**FINDINGS AND RECOMMENDATION
OFFICE OF PLANNING AND ZONING
ANNE ARUNDEL COUNTY, MARYLAND**

CASE NUMBER: 2024-0164-V

REQUEST

The applicant is requesting a variance to allow a dwelling with less setbacks than required on property located at 3692 Eighth Avenue in Edgewater.

ADMINISTRATIVE SITE PLAN

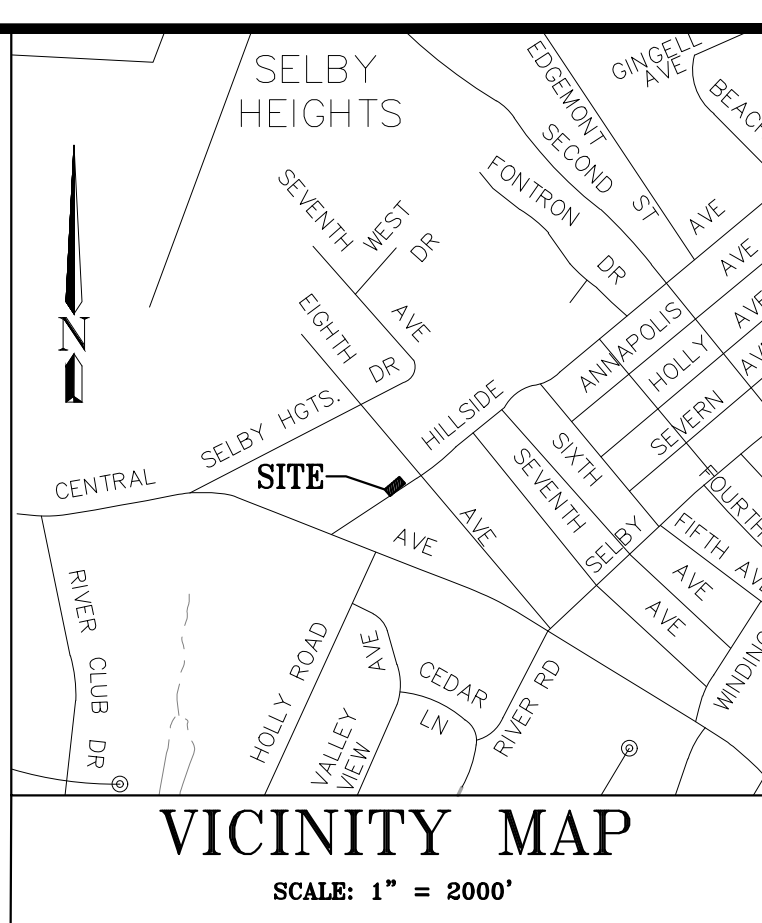
1. Stormwater management will be addressed through a bio-swale, permeable pavement, and entranced filter. The site did not show all the proposed SWM practices and please ensure that the SWM report and the proposed SWM on the site plan shall be matched.

4. Microscale stormwater facility(ies) design should incorporate safe conveyance for overflow discharges from 2, 10, 100-yr 24-hr storm events; plans should show overland relief paths for these storm events and ensure that no structures, or properties are negatively impacted or have water impounded against during these storm events.

7. Contours not labeled on the plans and lack of specificity on site topography; No details on addressing site and offsite runoff.
8. Overflow provided but no details regarding conveyance provided. In this case, based on the location and details, the runoff may be conveyed onto the neighboring property, impacting this property.

11. A soil boring is required per practice. The suitability, and siting of proposed SWM practices should be reviewed. Soil boring information including verification of the suitability of in-situ soils for infiltration shall be submitted. Describe the site's hydrologic, and topographic characteristics and provide a recommendation on the feasibility of various BMPs.

12. Based on the plan provided, it appears that the property will be served by a private well and the provided site plan is unclear on sewer is served for the property, please clearly show and label the existing and proposed SHC on the site plan.
